September 13, 2022

REF: Request for Additional Information
Venture Lighting International, Inc.
6675 Parkland Blvd., #100
Solon, OH 44139
Distribution License Number: 34-26659-03E
Docket No. 030-38541

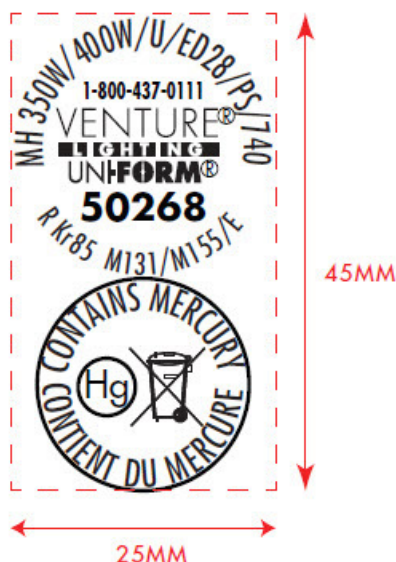
5. 10 CFR 32.14(b)(3) requires the applicant to submit the method of containment or binding of the byproduct material in the product. Please describe the method by which Kr-85 gas is introduced and the glass tube is sealed.

The Krypton-85 gas mixture is double-contained inside the metal halide lamp. It is first sealed in a quartz arc tube. Then the arc tube, surrounded by its glass sheath, is sealed inside the lamp envelope.

Fill gas for selected products is Argon mixed with a low concentration of Kr-85 gas. Fill gas tank is covered with a lead shield and stored in a cabinet allocated for this purpose. Fill gas tank is connected to the exhaust head with an isolation valve.

The metal halide pills, and in some cases, scandium are dispensed into the pinched body and gently melted under a cover gas of pure argon. The pinched body is cooled and then mercury is dispensed into it. The exhaust tube is connected to a special chuck and sealed to the pump/flush exhaust system. The exhaust system pumps out most of the gases in the pinched body and refills it with pure argon. This pump/flush operation is repeated several times. Then the fill gas (Argon-Kr85 mixture) flows into the pinched body and the correct fill gas pressure is established. The operator uses a hand torch to seal the exhaust tube very close to the surface of the body.
